**City of West Linn
PRE-APPLICATION CONFERENCE
SUMMARY NOTES**

February 6, 2014

SUBJECT: Removal of existing boat ramp/dock facility and construction of a two 240 foot long docks and 130 foot long launching ramp, plus additional fill, grading and driveways at the Cedaroak Boat Ramp (4600 Elmran Drive)

<p>Flowing Solutions 3305 SW 87th Avenue Portland, OR 97225 Phone (503) 297-6331 Fax (503) 297-6063</p>	SHEET TITLE: PROPOSED PLAN	DATE: 4/6/11
	PROJECT: CEDAR OAK PUBLIC LAUNCH RAMP NIXON AVE & ELMRAN DR WEST LINN, OR 97068	SCALE: 1"=60'
	RIVER/MILE: WILLAMETTE, RM 23.2	DATUM: NGVD
		SHEET: 4/10

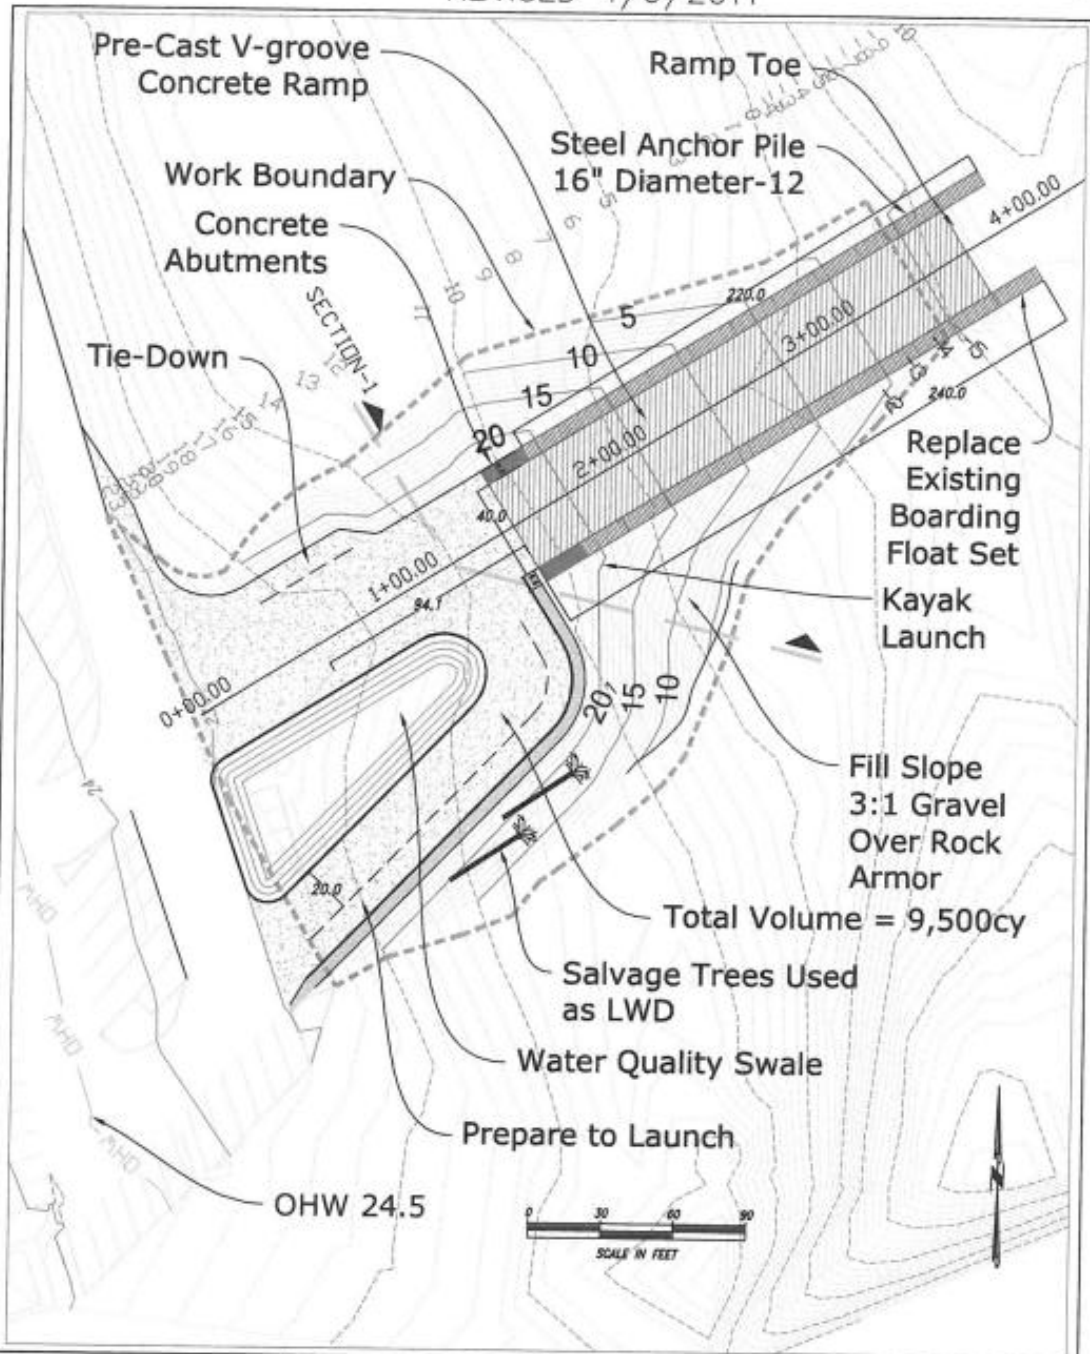
The existing double dock configuration and ramp is 150 feet long as measured from the Ordinary High Water Mark (OHWM). According to the Parks Department, the existing docks will be removed and new docks and ramp facility constructed which will extend approximately 250 feet into the Willamette River.

In a significant departure from the existing dock, which is anchored to existing grades along the river's edge, the proposal calls for placing 8,000 cubic yards of fill on the

shoreline which will extend about 400 feet into the river to form the elevated base for the boat ramp and docks. This would allow the new docks to start “further out”. The existing vehicle ramp between the docks is relatively flat for 50 feet whereas the proposed ramp would be flat for 160 feet. Both ramps then slope downwards to facilitate boat unloading and loading. The existing ramp toe of slope ends 240 feet from the shore while the new ramp toe of slope ends 370 feet from the shore.

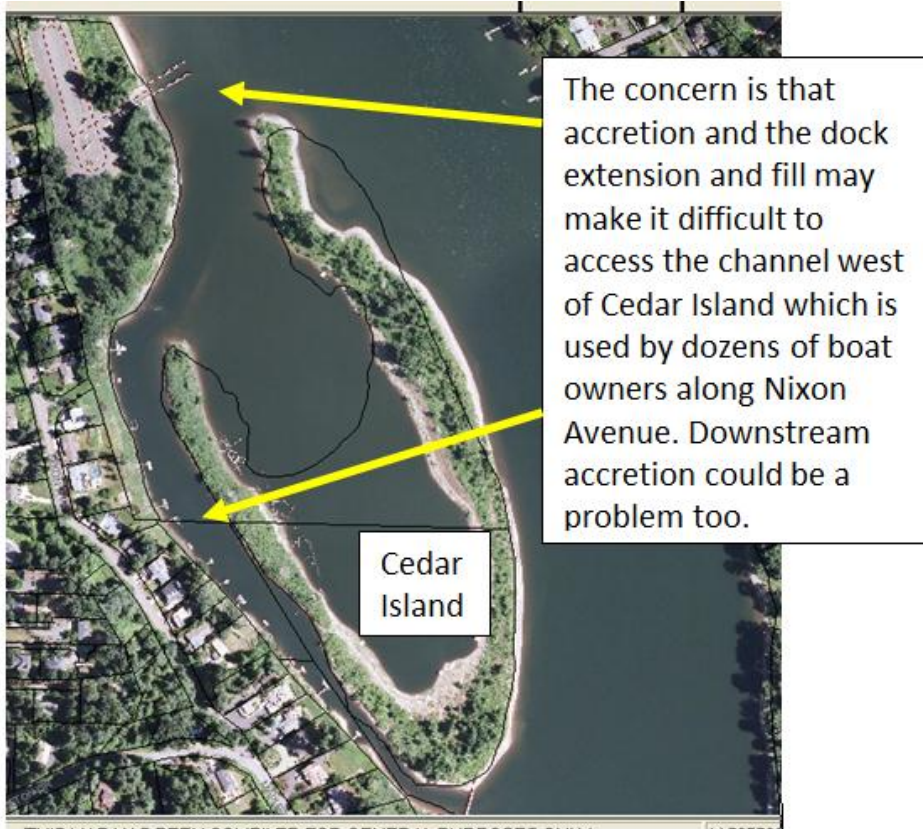
Metro's Habitat Conservation Areas (HCAs) are identified in green on the map above. All the site is high HCA.
